**UTC REVITALIZATION**

Project No. 2214; Work Order No. 41-1059  
 Proposed Changes to the University Community Plan  
 July 1, 2008

Errata to University Towne Center Revitalization Project Final EIR  
SCH No. 2002071071  
July 3, 2008

A draft version of the EIR for the proposed UTC Revitalization project (SCH #2002071071) was circulated for public review from August 9, 2007 to October 10, 2007. During the public review period a total of 78 letters or messages of public comment were received. Agencies, organizations/special interest groups and individuals submitting comments on the project are listed below, and organized by category.

**8. P.196 (Figure 33)**

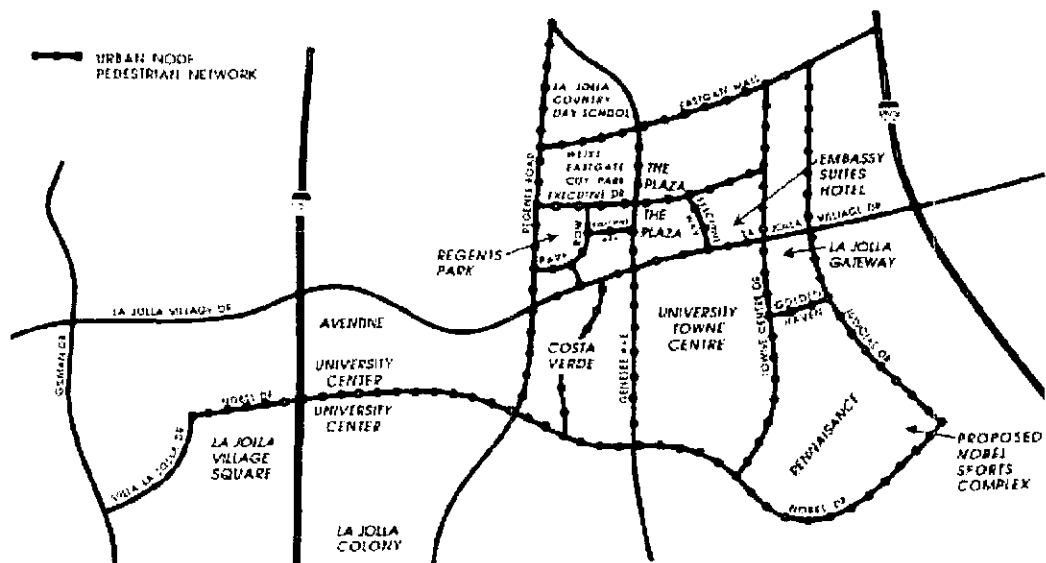
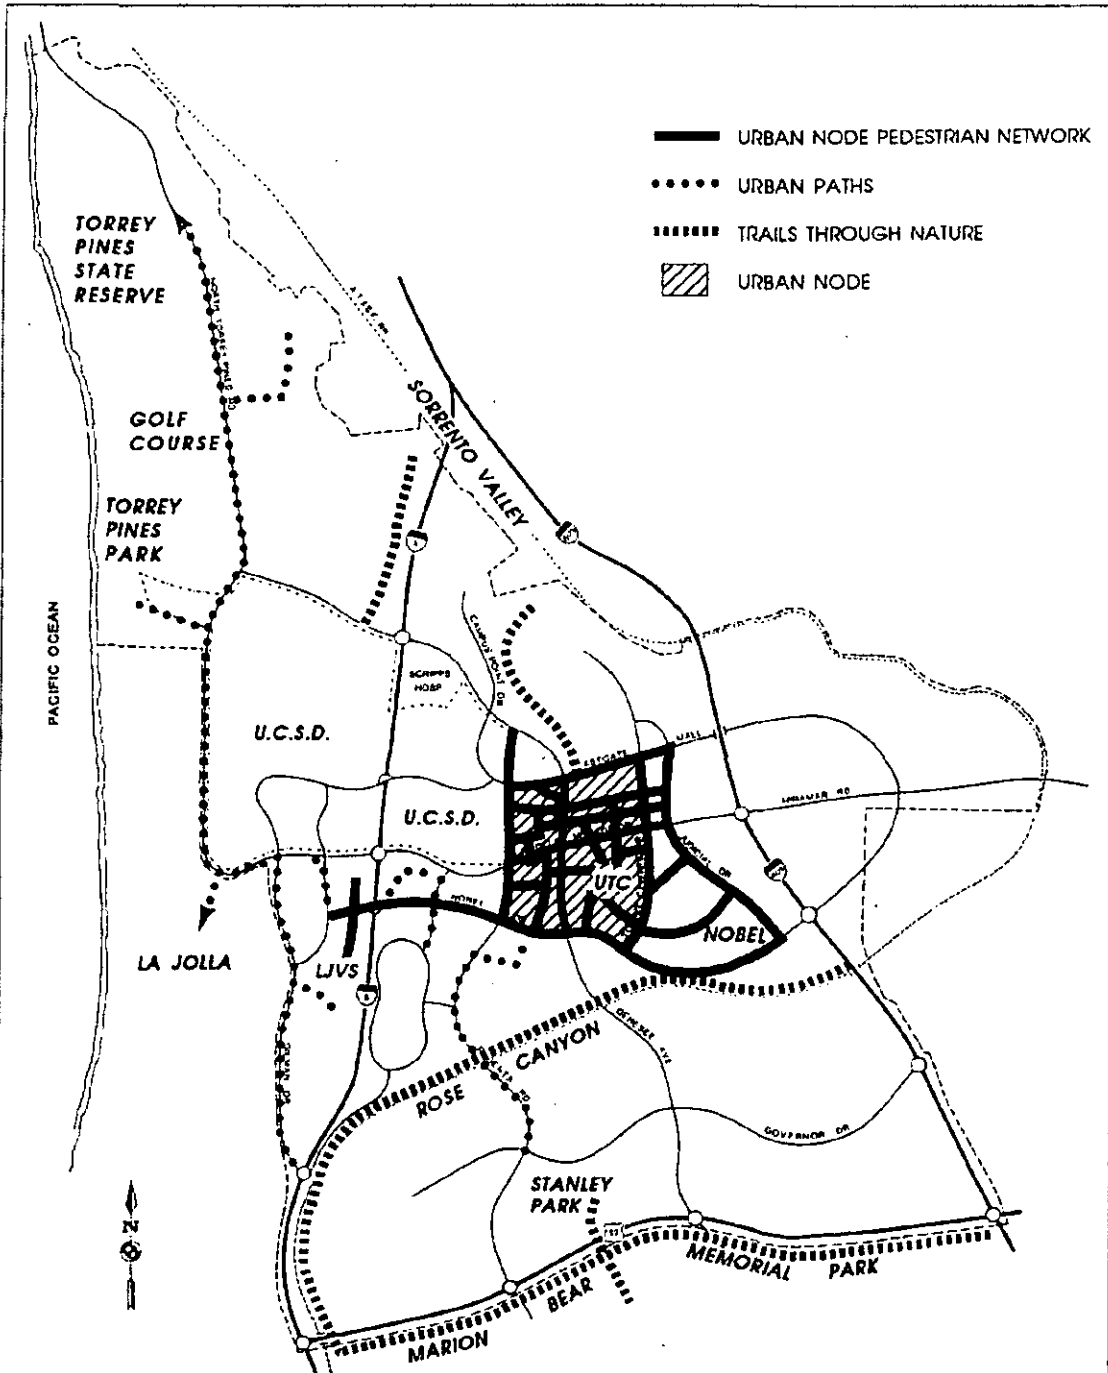
Add footnote to Figure 33 (Commercial Land Uses):

“In addition to the commercial land uses permitted on the University Towne Center site, residential uses may be included under the approved Master Planned Development Permit for the site, up to a maximum of 300 residential units. See Table 3, Land Use and Development Intensity, area #43 for further detail.”
